Juniper Court / Building A

Exterior rehabilitation

East canopy-to-wall return / E-01

QSP-SAMPLE-001 / finding F-001

E-01: vector location diagram only. No installation dimensions are given. E-02 marks a planned review location, not a second reported defect.

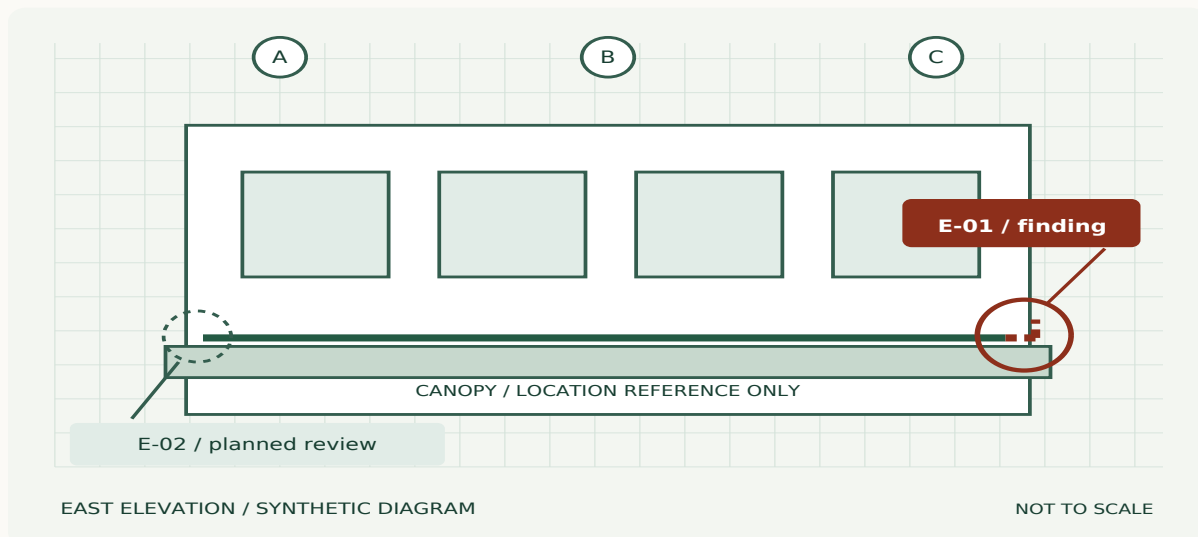
At east return E-01, the visible termination stops short of the adjacent flashing. Continuity could not be verified at the return. Review the detail and proposed correction before concealment.

September 24: a simulated completion response describes the cover in place, without locating E-01 or showing the interface before concealment. The reviewer requests the missing basis. F-001 remains open.

Revision C clarifies the east return. Install the indicated continuous transition and present the interface for the designated review before concealment.

September 28, 2026 / 09:10 CDT. The sample reviewer records an observation of the exposed E-01 interface against illustrative detail revision C.
